Comments made within the framework of the Espoo procedure in relation to the environmental impact study (EIS) of the planned opening of the Rosia Montana mine, compiled by the Hungarian Ministry of Environment and Water on the basis of government and non-governmental organizations

In August 2002 Hungarian Ministry of Environment and Water notified the Ministry of Environment and Water Management of Romania that Hungary can be potentially affected by the implementation of the planned mining investment in Rosia Montana. Hungary, as a potentially affected party, asked for the application of the UN ECE Convention on Environmental Impact Assessment in a Transboundary Context (Espoo Convention) after the permitting procedure of this mining activity had been launched by Romanian authorities. The international environmental impact assessment procedure according to Espoo Convention was started in January 2005, when answering the notification according to the Convention sent by the Romanian party, Hungary confirmed its intention to participate in the procedure. Romanian Ministry of Environment and Water Management sent the environmental impact assessment documentation compiled by the invest

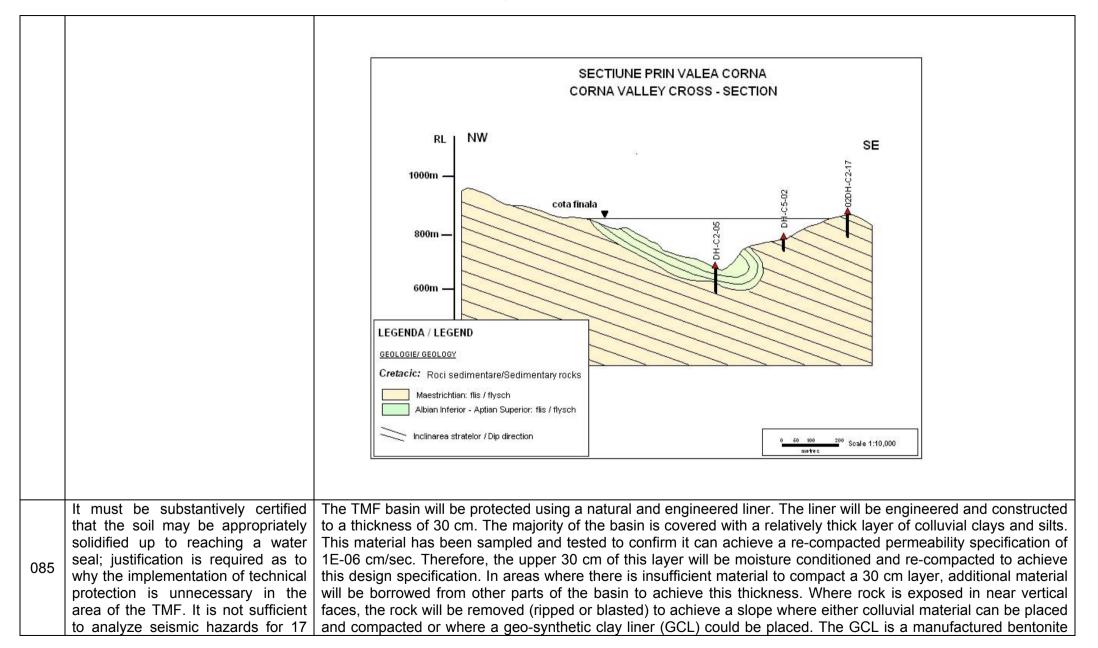
083	The compilation also uses materials already included, in a moderately revised form. It contains descriptions related to the design, construction and operation of TMFs but less verifiable data.	The Tailings Facility Management Plan - TMFP - is a comprehensive plan that Roşia Montană Gold Corporation (RMGC) will implement in order to minimise the risks associated with the operation of the Roşia Montană Project Tailings Management Facility (TMF), in conjunction with ore processing operations. The <i>Tailings Facility Management Plan</i> conforms to applicable international and Romanian standards for the operation of such facilities. It provides general information on the geological and geotechnical setting of the TMF; describes its overall design, operation, monitoring, and closure aspects; and addresses the specific measures RMGC will employ to manage the facility in a safe and environmentally conscientious manner over the life of the mining operation.

This management plan applies only to Roşia Montană Project activities. The Plan will be subject to annual review and update in response to internal and external reviewer comments, regulatory changes, changes in mining operations, stakeholder communications, internal performance verification and management review results, and other factors. Implementation of the <i>Tailings Facility Management Plan</i> will also be supported by a suite of standard operating procedures. These procedures will be compiled in the <i>RMGC Standard Operating Procedures Manual</i> , the development, review, approval, distribution, and update of which is controlled by the <i>Roşia Montană Project Environmental and Social Management Plan</i> .
084	An accurate geological - geotechnical cross-section is not available in relation to the area of the TMF.	All locations for facilities have been tested with the appropriate level of core drilling, geophysical surveying, and test pitting, with rock core samples collected as well as soil samples for geotechnical test work. All of this is work is covered under the feasibility and engineering study and the results are used for the design of the facilities. The results of this were used for the EIA, but not all the details for all drill holes, test pits, surveys and test work are reported in the EIA, as this is outside the scope of the EIA. In total, 221 geotechnical drill holes have been completed, for 9357.42 metres of core, and 172 test pits have been created. In addition, 886 other drill holes have

been drilled, for 127,195.74 metres, to test the various aspects of the project, including geotechnical aspects and data, and approximately 70,000m of underground workings have also been geotechnically logged and tested. The details of this work are included in the feasibility study. In regards to the Corna Valley area, 72 drill holes for 3064.84m were completed and used for the appropriate test work as well as test pits and geophysical and geological surveys. Chapter 4.5 of the Assesment Study of the EIA presents in detail the geology of the area, including drawings of the regional and local geology. For the tailing pond, cross sections of the tailing pond are presented in the Annexes at Technological Processes: Figure: 2.19 – Scheme of the tailing pond system and Figure 2.20 – Transversal cross section of the tailing pond dam and of the retention secondary dam. In the management plan of the tailing pond, Figure 5.2 presents the geological profile along the tailing pond. Drawings 03A; 03B; 07A; 07B and 09 show cross sections of the main and secondary tailing pond. Data from the geotechnical study is described in section 2.3 (page 28) within the same plan. All the plans and cross sections present the faults, geological structure and geotechnical conditions.

Please see the geological profiles of Corna Valley that are attached to this answer. In the geological profiles of the tailing pond projected for Corna Valley, there are no known faults that could endanger the safety of the pond.

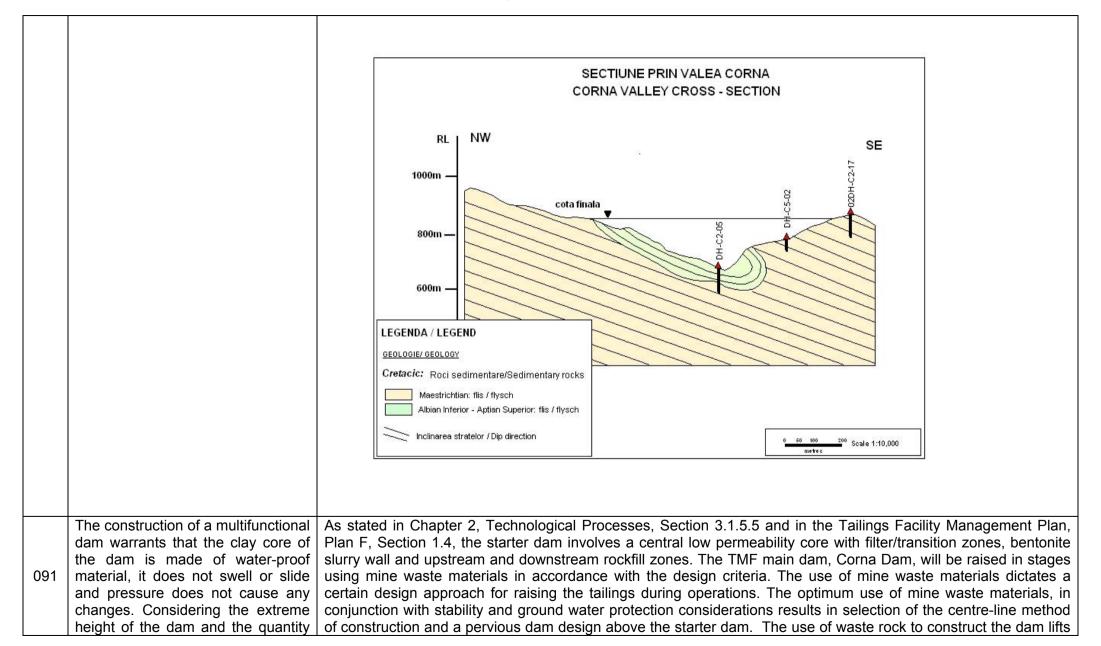
090	The Corna Valley is situated in a fault zone which has not been adequately researched with regard to the long term stability of the dam, the characteristic condition of the soil and the water sealing capacity of the TMF's support.	All locations for facilities have been tested with the appropriate level of core drilling, geophysical surveying, and test pitting, with rock core samples collected as well as soil samples for geotechnical test work. All of this is work is covered under the feasibility and engineering study and the results are used for the design of the facilities. The results of this were used for the EIA, but not all the details for all drill holes, test pits, surveys and test work are reported in the EIA, as this is outside the scope of the EIA. In total, 221 geotechnical drill holes have been completed, for 9357.42 metres of core, and 172 test pits have been created. In addition, 886 other drill holes have been drilled, for 127,195.74 metres, to test the various aspects of the project, including geotechnical aspects and data, and approximately 70,000m of underground workings have also been geotechnically logged and tested. The details of this work are included in the feasibility study. In regards to the Corna Valley area, 72 drill holes for

3064.84m were completed and used for the appropriate test work as well as test pits and geophysical and geological surveys. For the Corna Valley no faults or structures are active and none have been for approximately 7 million years. All structures have been adequately tested as summarized above in regards to all geotechnical and

structural aspects for the engineering study where all such information is available. Chapter 4.5 of the Assesment Study of the EIA presents in detail the geology of the area, including drawings of the regional and local geology. For the tailing pond, cross sections of the tailing pond are presented in the Annexes at Technological Processes: Figure: 2.19 – Scheme of the tailing pond system and Figure 2.20 – Transversal cross section of the tailing pond dam and of the retention secondary dam. In the management plan of the tailing pond, Figure 5.2 presents the geological profile along the tailing pond. Drawings 03A; 03B; 07A; 07B and 09 show cross sections of the main and secondary tailing pond. Data from the geotechnical study is described in section 2.3 (page 28) within the same plan. All the plans and cross sections present the faults, geological structure and geotechnical conditions.

Please see the geological profiles of Corna Valley that are attached to this answer. In the geological profiles of the tailing pond projected for Corna Valley, there are no known faults that could endanger the safety of the pond.
